RE: 3-SC-22-C 3-D-22-UR S&E Properties 6513 and 0 Babelay Rd

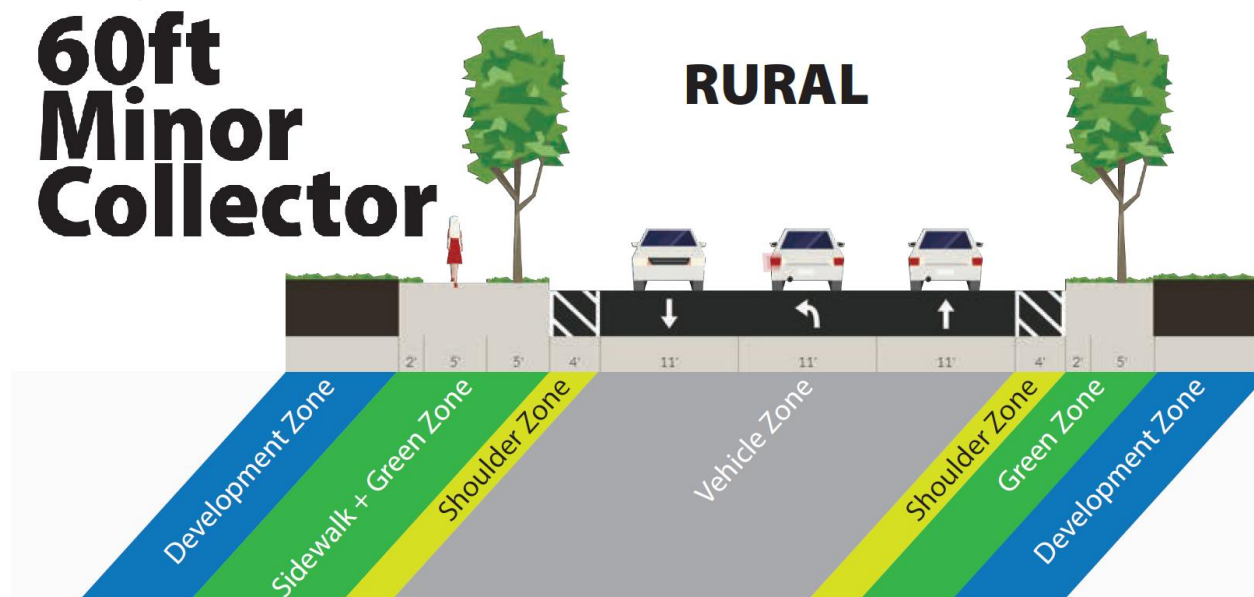
The condition of widening Harris Rd to 18' helps a tiny bit. However, it is a minor collector, and the Major Road Plan calls for this cross section in the Rural area (11' wide lanes, and 5' wide sidewalks):

We do believe that Harris should be improved to the standard depicted in the Major Road Plan.
